August 19, 2016
BOARD OF COUNTY COMMISSIONERS
ORANGE COUNTY, FLORIDA
IFB NO. Y17-702-CC/ADDENDUM NO. 2
REGIONAL HISTORY CENTER CHILLER & COMPUTER ROOM AIR
CONDITIONING UNIT REPLACEMENT

This addendum is hereby incorporated into the bid documents of the project referenced above. The following items are clarifications, corrections, additions, deletions and/or revisions to, and shall take precedence over, the original documents. Underlining indicates additions, deletions are indicated by ~~strikethrough~~.

SHEET INFORMATION:	
JOB No. 100048247	Date Issued: 05/31/16
Designed By: JLA	Sheet Number:
Checked By: GH	E-001
OC Review: GH	
Phase: BID

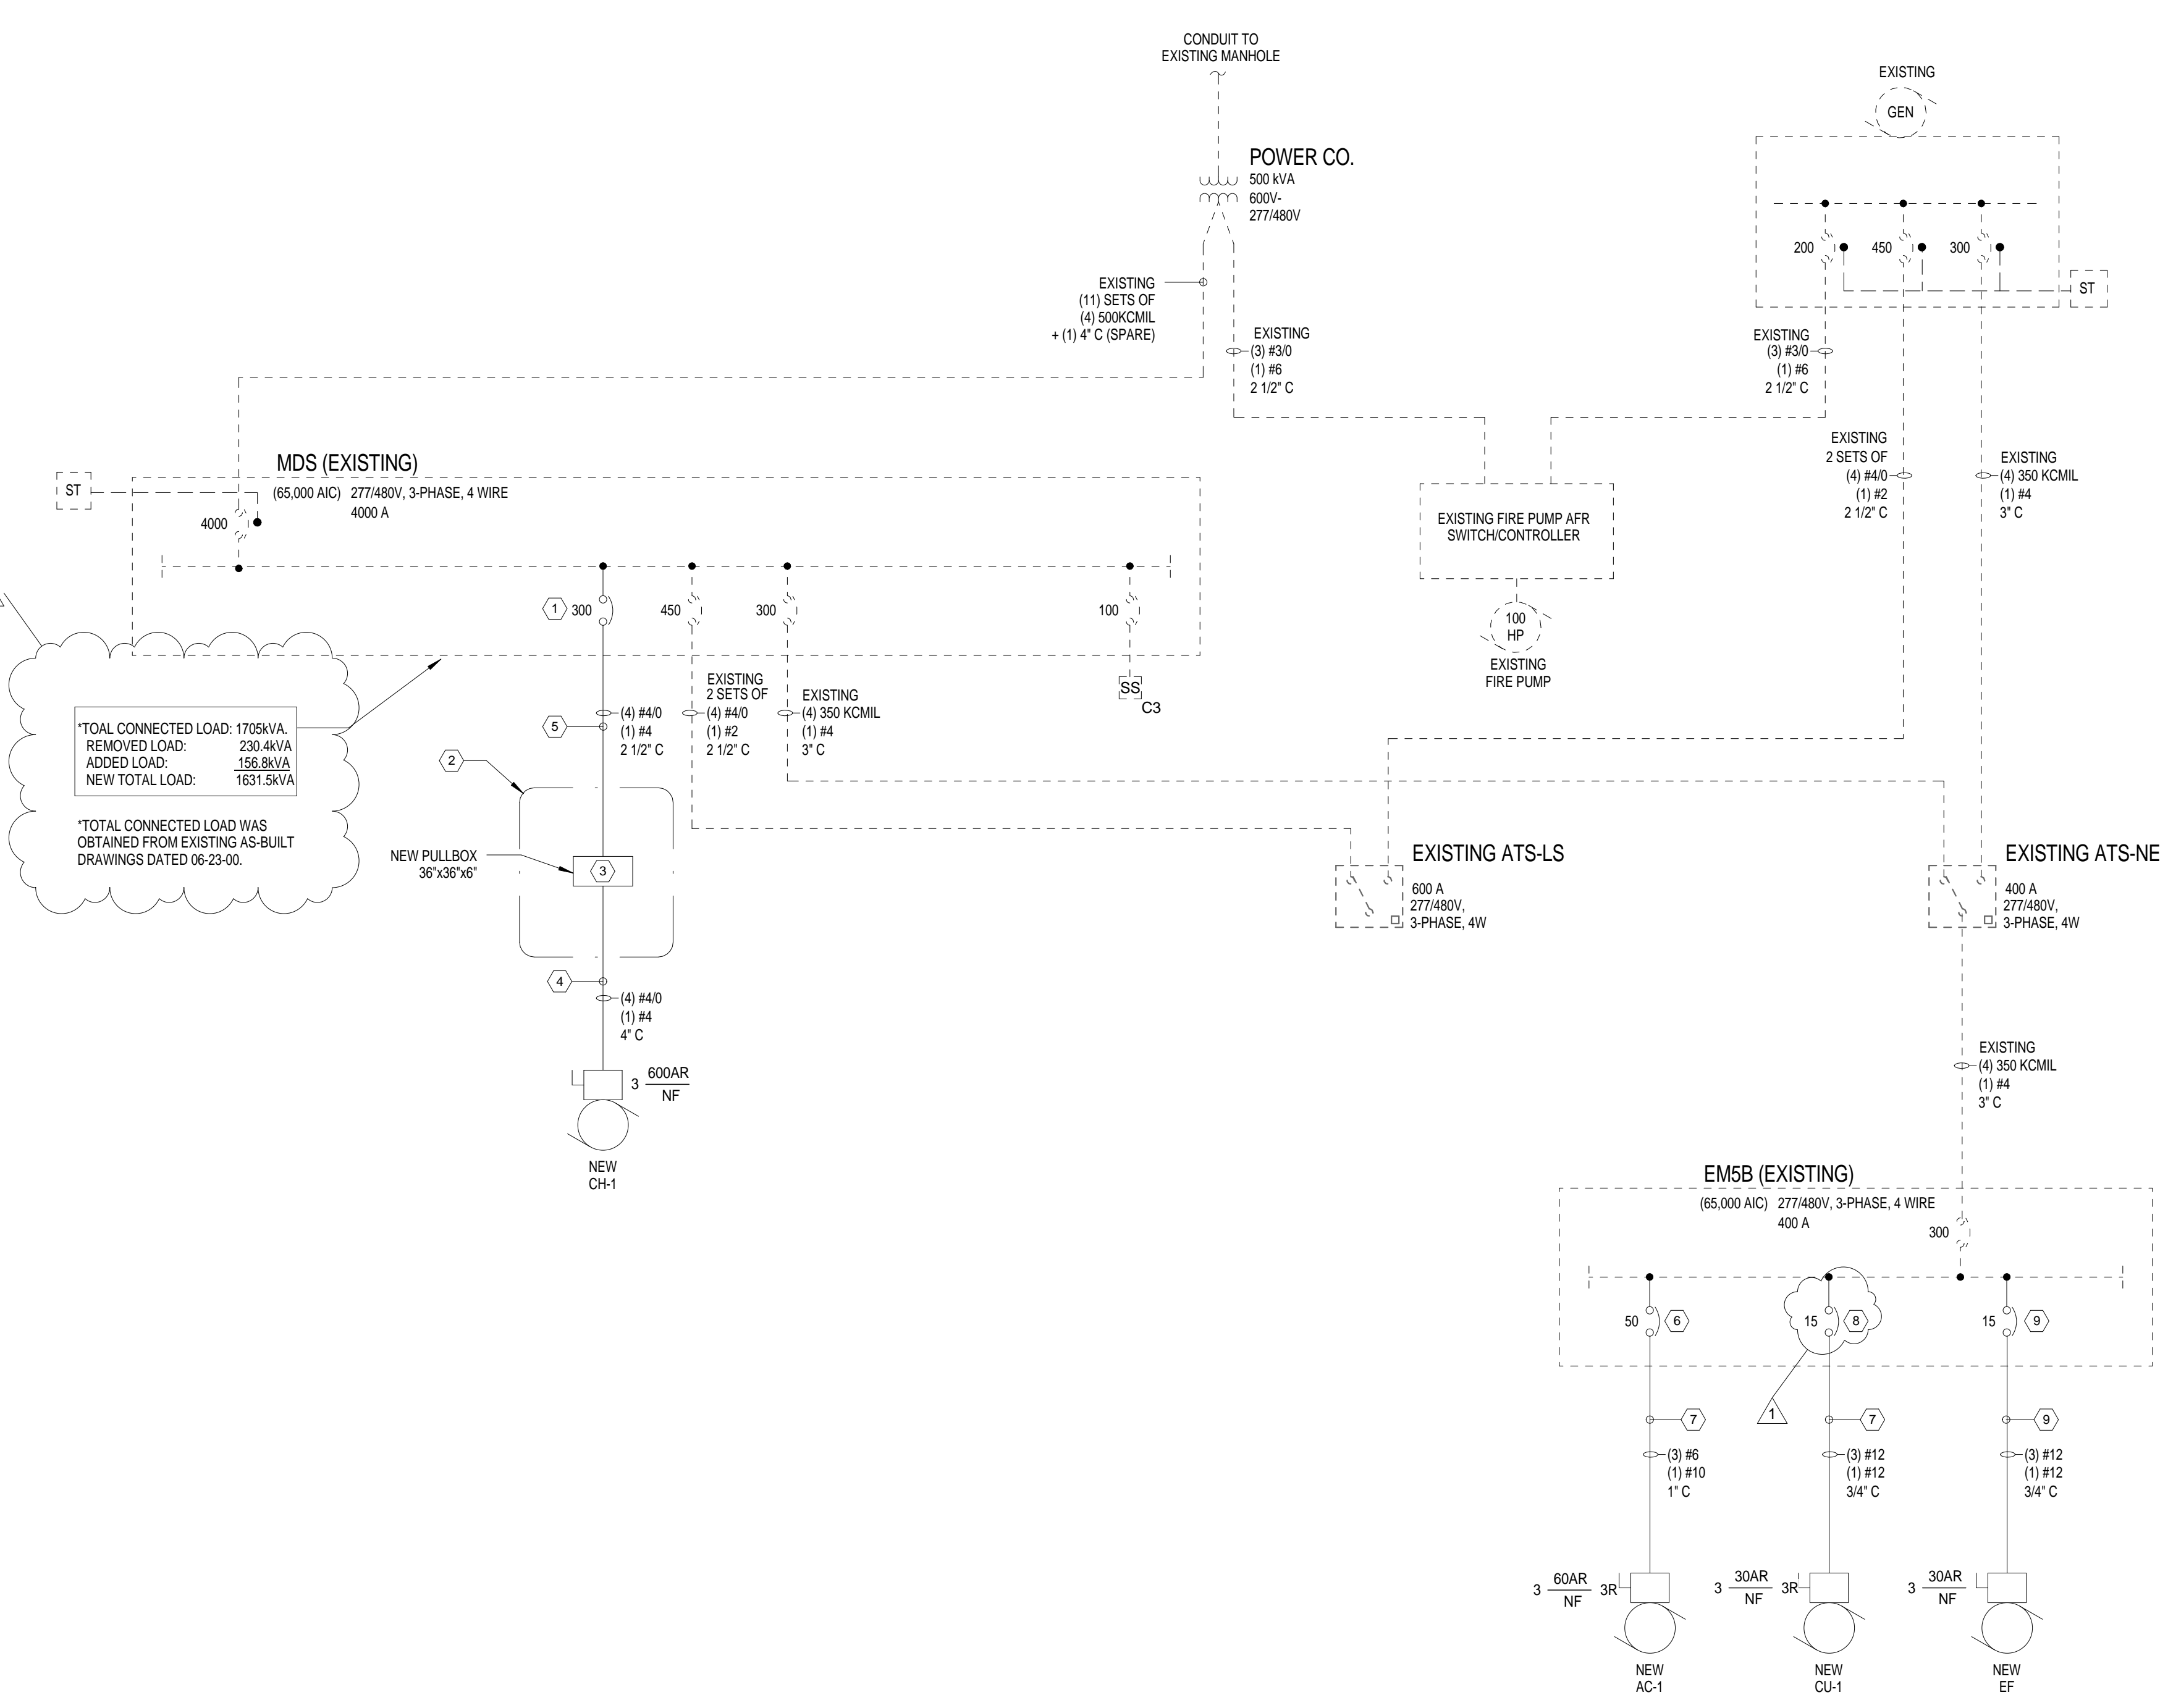
3. **Question:** On the electrical drawing page E-001, keyed notes 1, 4, and 5, I noticed it is calling for a single set of (4)4/0 with 1 #4G fed from an existing breaker with a new 300 amp rated plug. Per NEC 310.15(b) 4/0 wire is good for 230 amps well below the 300 amp rated plug and the plans are calling for a non-fused disconnect. Please advise whether the size of the wire will be increasing or if the size of the rating plug is being reduced? Thank you for your time looking into this question.

- M-202 HVAC Details (Double Door design requirements added to Detail 1. Contractor to provide Florida Product Approval.
- E-001 (Voltage drop calculations have been added. A load summary for the building main switchboard and panelboard schedule for panel EM5B have been added).
- EP-101 (Existing receptacle has been added).
- EP-102 (Existing receptacles have been added).

Answer: In general, the circuit breaker for a motor circuit shall be sized in accordance with NEC paragraph 430-52(B) and Table 430.52. It provides short circuit and ground fault protection for the feeder and motor, while allowing the higher motor starting in-rush current. For this application, the motor feeder and circuit breaker trip unit are sized in accordance with the

chiller manufacturer recommendations. It is not necessary for the circuit breaker to match the ampacity of the feeder as suggested by the Contractor. The chiller motor thermal overload protection will also provide overload protection for the motor feeder. No changes to the electrical design are needed.
